City of Portland, Maine - Building or Use Permit Application

Proposed Use: Multi- Tenant Condo- Unit #8 - Interior renovation & Add a Roof Deck	Proposed Project Description: Unit #8 - Interior renovation & Add a Roof Deck
--	---

RE: 49 Morning Street – 003 B004 – R-6 – roof top deck – permit #07-0186

Date April 2, 2007	Scale 3/4" = 1'-0"	Revisions:	Project:
EXISTING ROOF FRAMING AND NEW DECK SHIMMING DETAIL			JENKINS CONDO
			MORNING STREET PORTLAND, ME
		ARCHETYPE, P.A. ARCHITECTS	
		48 Union Wharf Portland, Maine 04101 (207) 772-6022 Fax (207) 772-4056

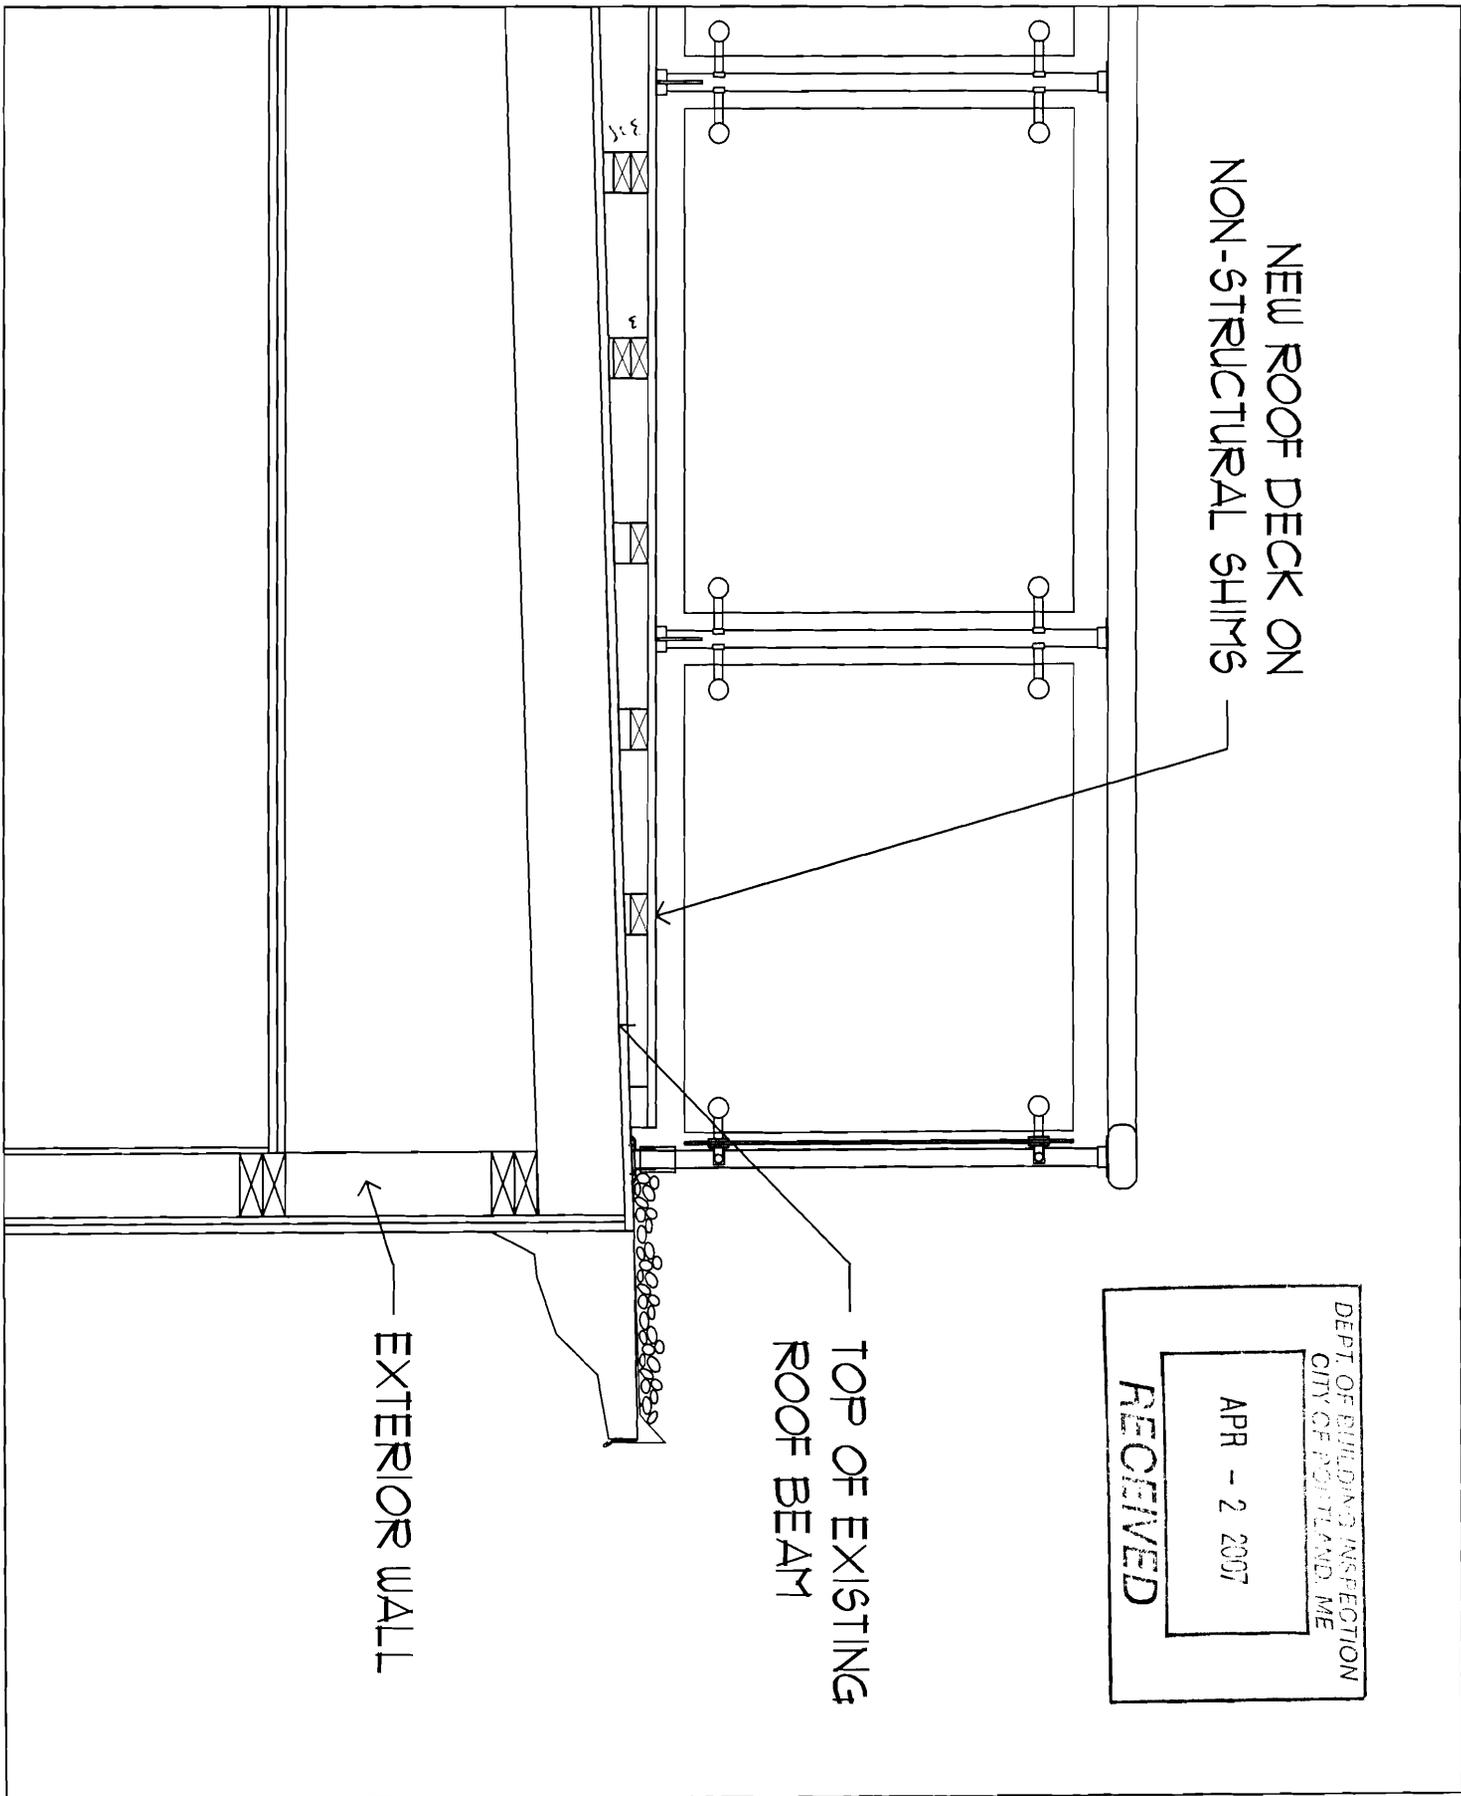
4/2/2007-amachado: Reviewed elevation plans. Height of building from grade to top of roof is over 45'. Don't know what height is to roof beams or what the average grade is. Deck has structural support, so it is adding height to the building and therefore is making a legally nonconforming building more nonconforming. I talked to Matt Brewer, emailed him and sent a letter. He said that he would get back to me.

Thanks for the email. I just need a little more clarification on exactly what the shims are. On the full size set of plans the shims scale at 3.5" wide. I know that the height varies. How long are these shims? Do they go all the way across underneath or how are they placed? Maybe a birds eye view of the deck showing where the shims will be located underneath would help.

The shims would be 2 by 6's ,ripped to the slope of the roof and continuous providing nailing at 16 inches on center. The contractor will frame around the outer edge. The 2 by 6 box just sits on the EPDM or floats. We then have a hold down clip on the outer edge of the railing to prevent uplift shown on detail 6 and 7 drawing A2.

In regards to your concerns on the proposed roof deck at 49 Morning Street I have the following to report

1: The existing building will not be changed in height as we are not altering the height of the existing roof beams.

2: The proposed roof deck will be sitting on non structural shims ,which allow the roof deck to be level ,without changing the slope of the existing roof.

3: Attached is a drawing showing the existing roof beam location and the proposed deck

MORNING ST. ELEVATION

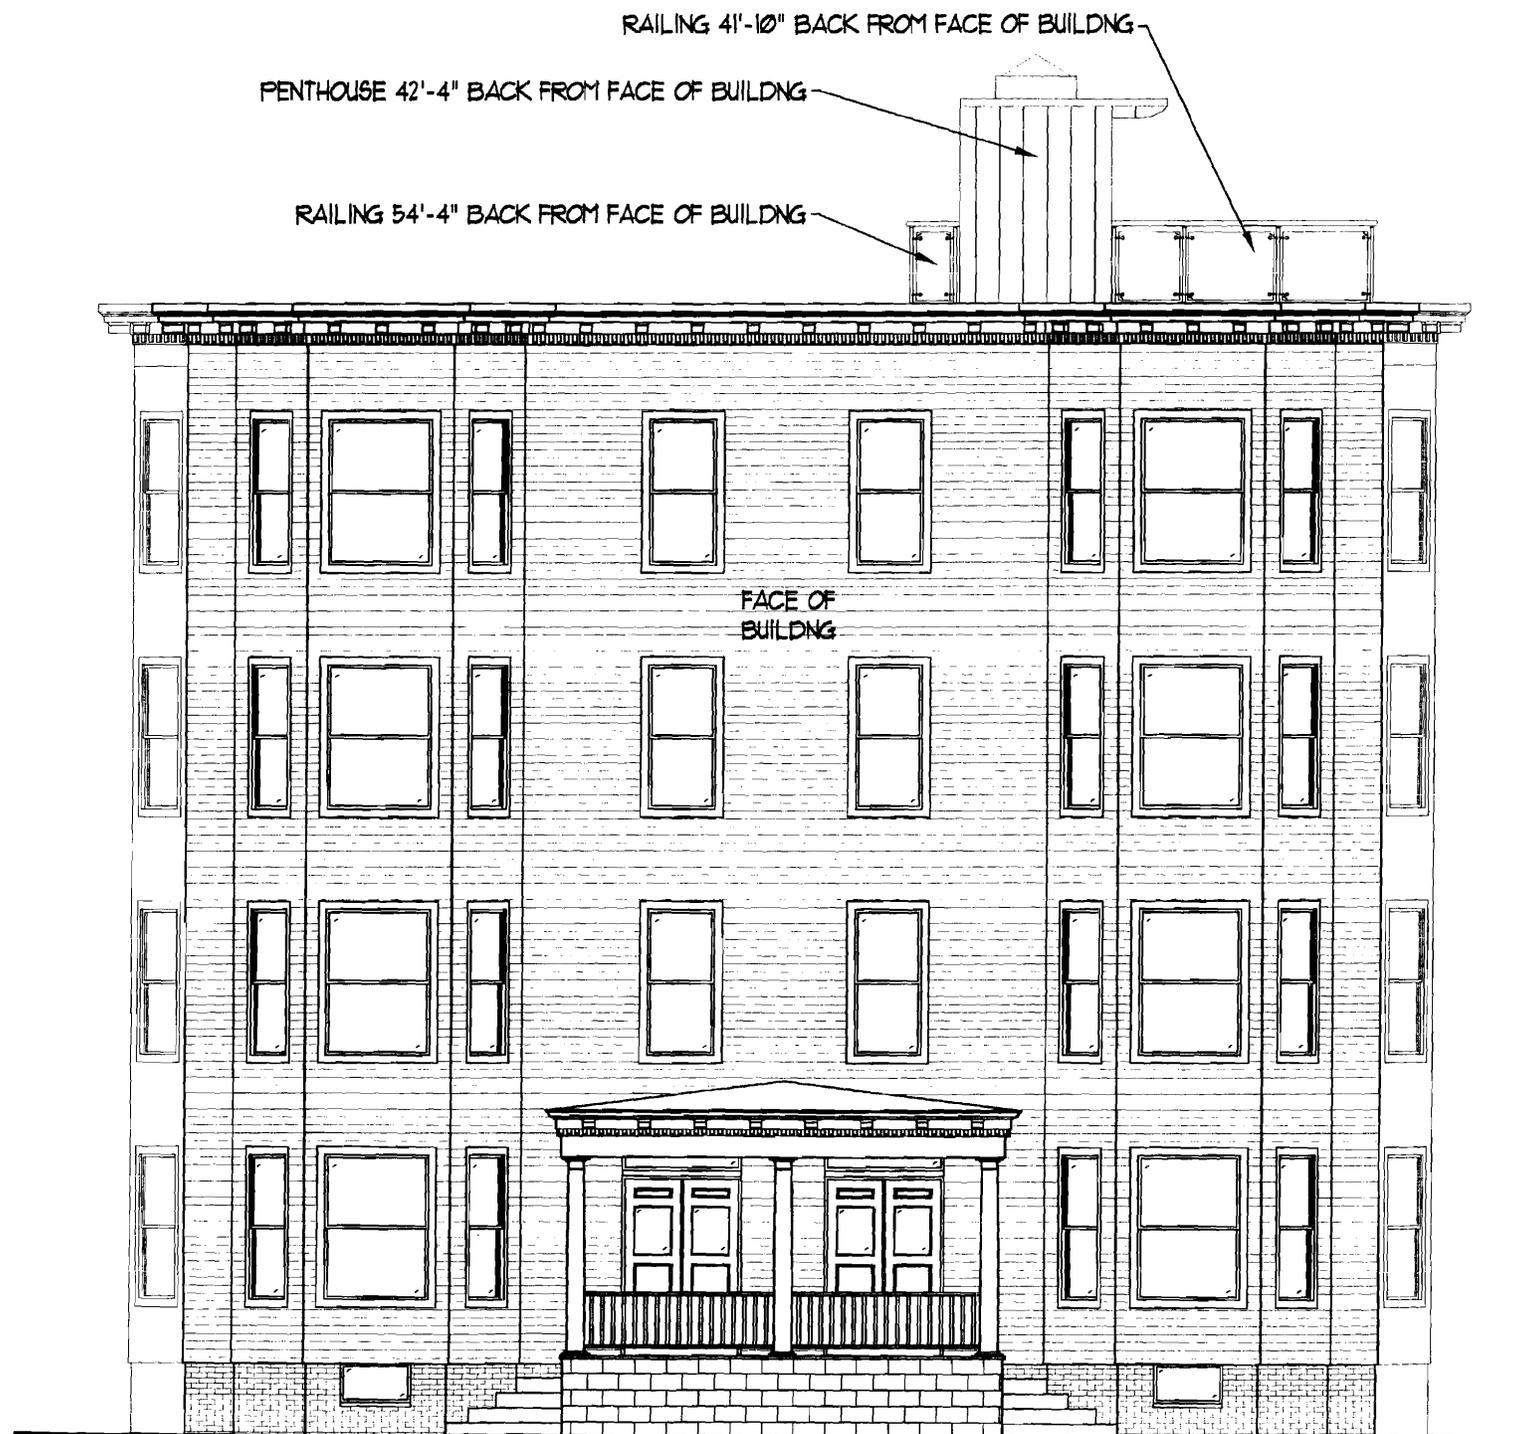
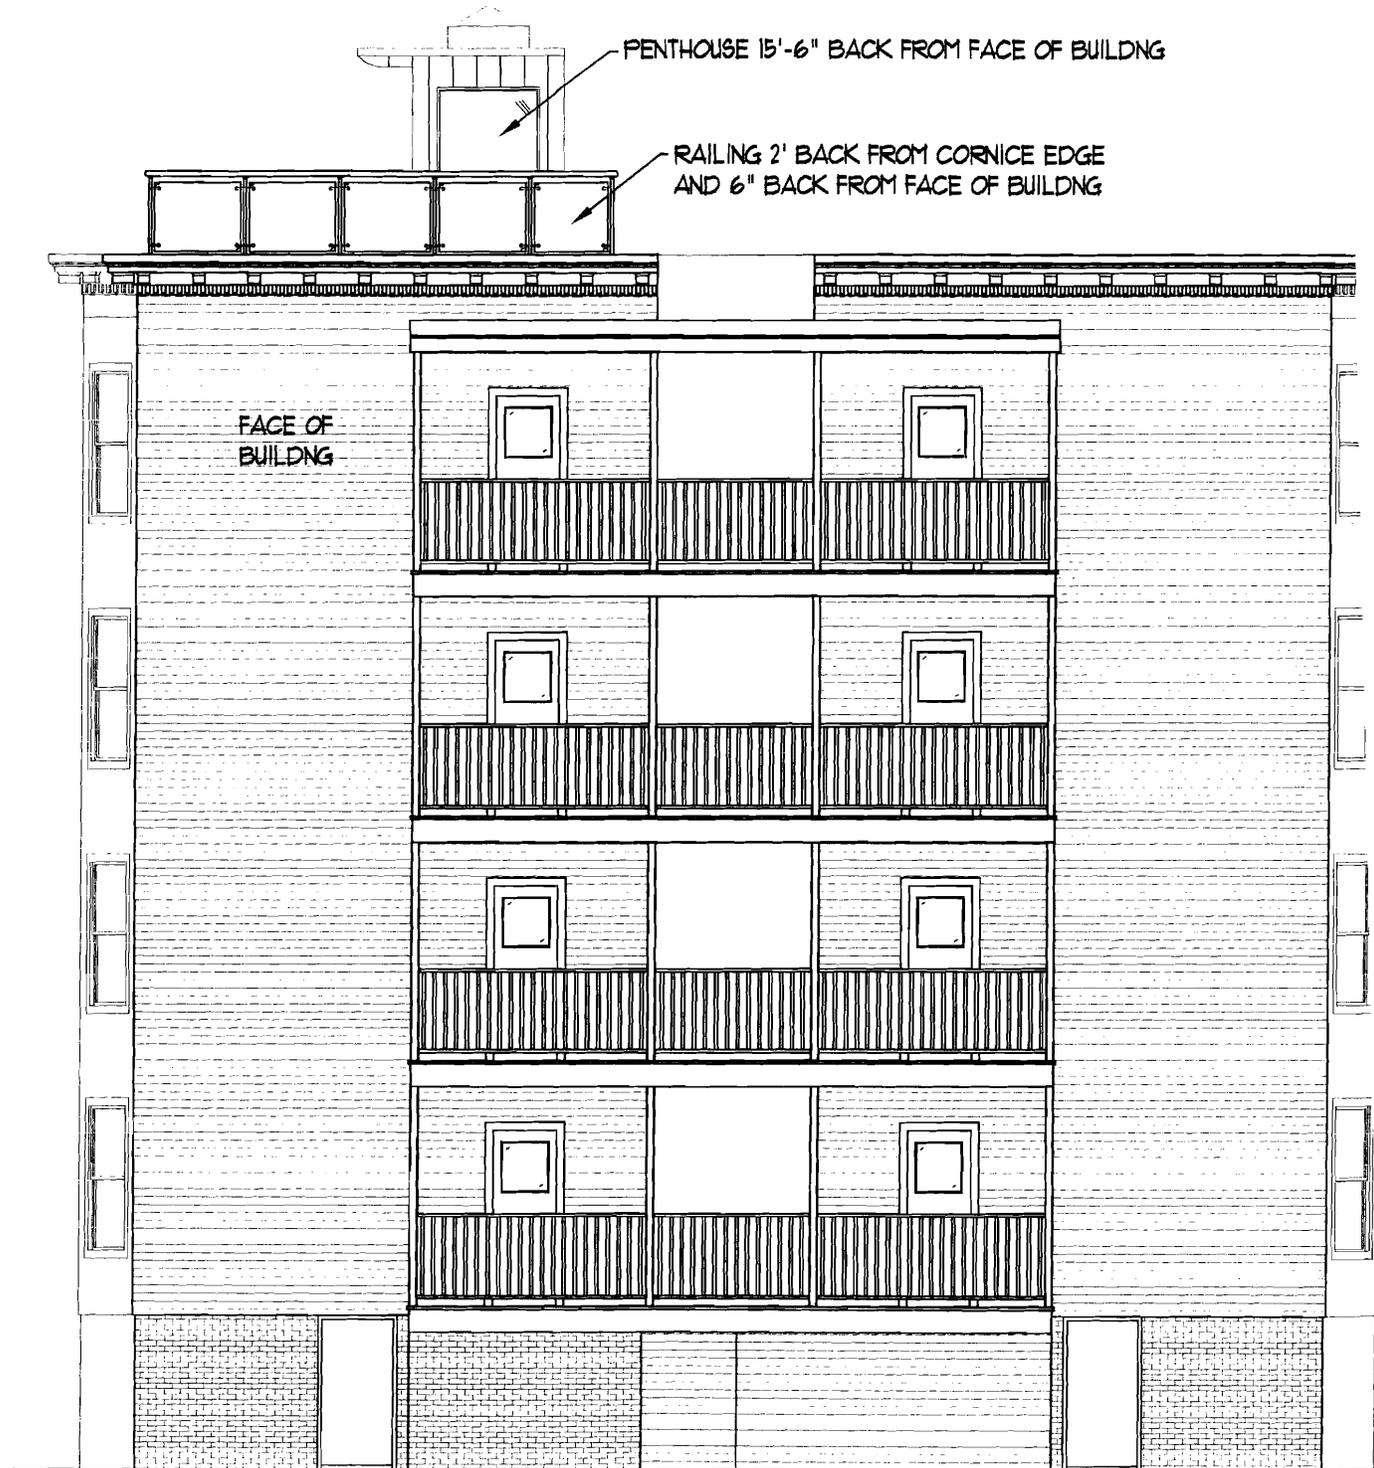
In reviewing the elevation plans today, I discovered that the roof top deck exceeds or is close to exceeding the maximum allowable building height in the R-6 zone. Section 14-139(1)(g) of the ordinance states that the maximum allowable building height for a principal building in the R-6 zone is forty-five feet. Section 14-47 of the ordinance states that the height of a building with a flat roof is measured from grade to the highest point of the roof beams. The elevation plans that were submitted did not show the roof beams, so I was unable to measure the actual height of the building. Measuring to the top of the roof puts the building over the forty-five foot maximum allowable height. I need a set of elevation plans that show the roof beams. Also the grade of the building slopes down from the front of the building to the rear of the building, so I need to know what the average grade is. Without this information, I cannot tell if the proposed roof top deck meets the maximum allowable height. Since the proposed deck will sit on shims, it is on structural supports, so the height of the roof is increased. The permit is on hold until I receive the necessary information.

I received the full elevation plans of the whole building from Archetype, P.A. Architects on Friday, March 30, 2007. In the R-6 zone the maximum allowable height of a principal structure is 45' (section 14-139). In a building with a flat roof, the height of the building is measured from grade to the highest point of the roof beams (section 14-47). The elevation plans did not show the roof beams. On the elevation plans, the grade also slopes down from the front of the building to the rear. I scaled the distance from the grade to the top of the roof at the front corner of the building which came out to 46'10". I also scaled the distance from grade to the top of the roof at the back corner of the building which came out to 50'3". I could not scale to the highest point of the roof beam, since it was not shown on the plan, but both heights that I scaled were over the maximum 45' height limit. The proposed roof deck is going on shims on top of the existing roof. Since these are structural supports, they are adding to the height of the building which is already over the maximum allowable height, and therefore with the information that I have received so far, I have to deny the application to build the roof deck.
